# Zoning Confirmation Report

**Comments: June 13, 2025**

**Responses: July 9, 2025**

**Subject: Feedback Form – Completeness Review  
Site Plan Control Application and Plan of Condominium Application  
615 Mikinak Road**

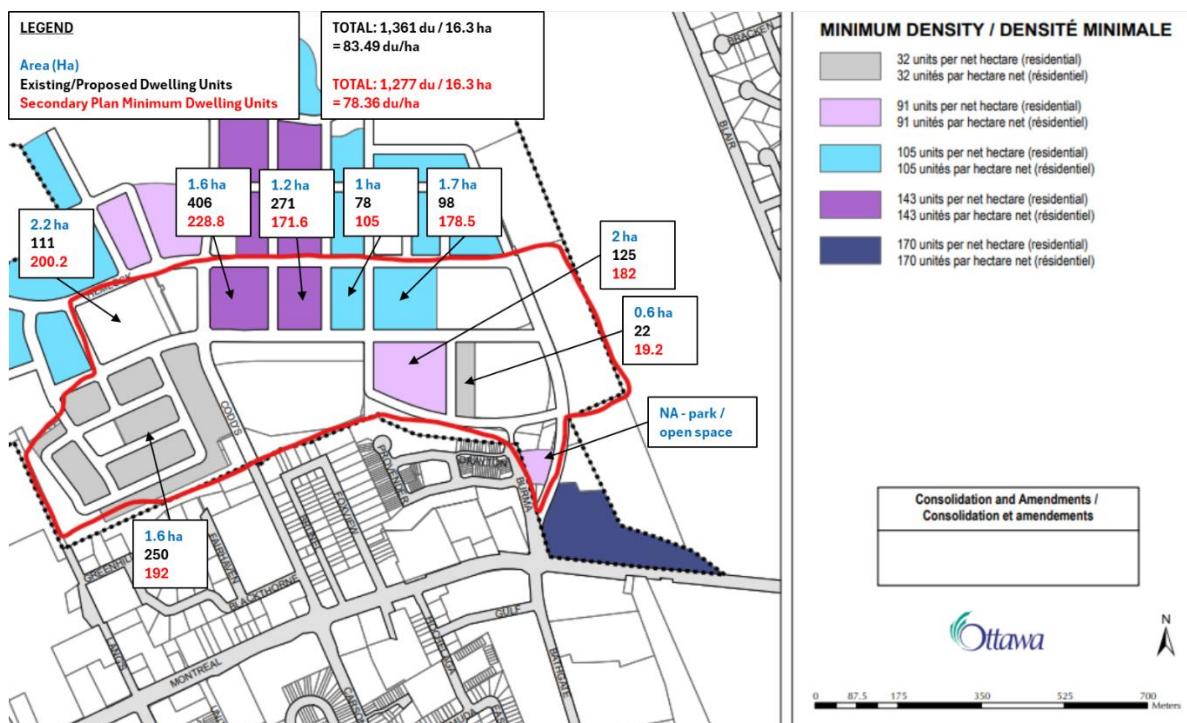
1. As per the Secondary Plan, a density of 91 units per hectare is contemplated on the subject lands, where the school board decides not to exercise its right to purchase a school block. Please provide rationale as to how the proposed development meets the densification targets of the policy framework, such as how Phase 1A achieves the density targets of the Secondary Plan. Zoning relief to permit the proposed development will need to demonstrate consistency with the policy framework.

**Response:** In the pre-consult feedback form the City stated the below:

*“Required density is 91 units per hectare. That said, we interpret the Secondary Plan density targets applying at a broader scale to the phase of the subdivision, typically supported by a Master Concept Plan. I would ask that you examine the whole of Phase 1 (boundaries identified in the following screen capture) to ensure that we are achieving the density envisioned for this phase of development.”*

The below analysis reflects the area identified in the above City comment from the pre-consult. The existing/proposed density exceeds the minimum density requirement by 5 dwelling units per hectare, which equates to 84 total units over the area of the phase identified by the City in the screen capture).

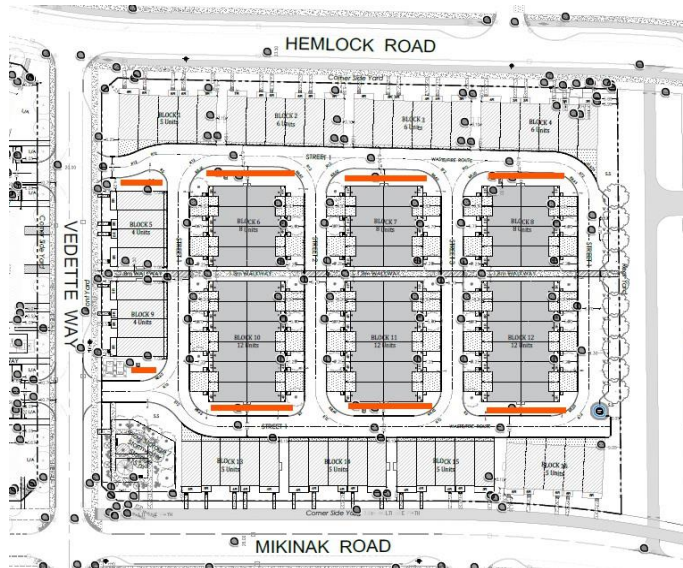
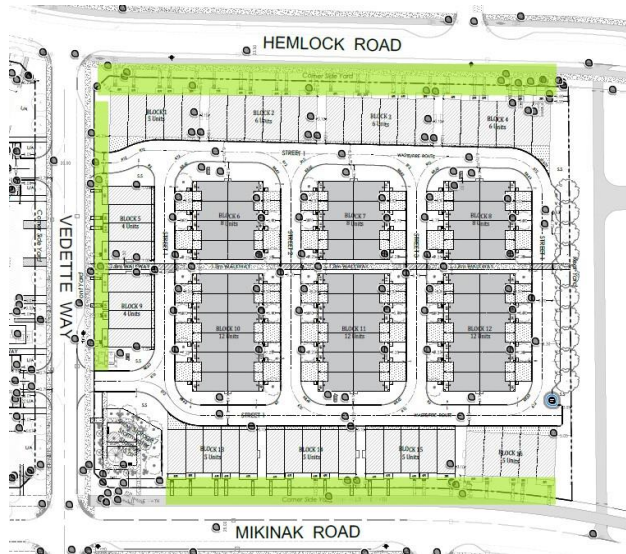
2. Tree Planting: Staff recommend increased tree planning along interior and

boundary streets. In particular:

- a) Can the landscaped areas south of Blocks, 10, 11, and 12 and north of Blocks 6, 7, and 8 support the planting of new trees based on the recommendations of the Geotechnical Report's findings? Can a deep, lean, concrete foundation be implemented, in order to reduce the required setbacks from the trees to the foundation?

**Response:** With sensitive marine clay soils present on site, we are required to maintain 4.5m foundation offsets. With required 1.5m curb offsets, trees are unable to be installed adjacent to Block 6, 7, 8, 10, 11, 12. There are also underground servicing conflicts at all noted areas further limiting tree planting, regardless of the foundation design.
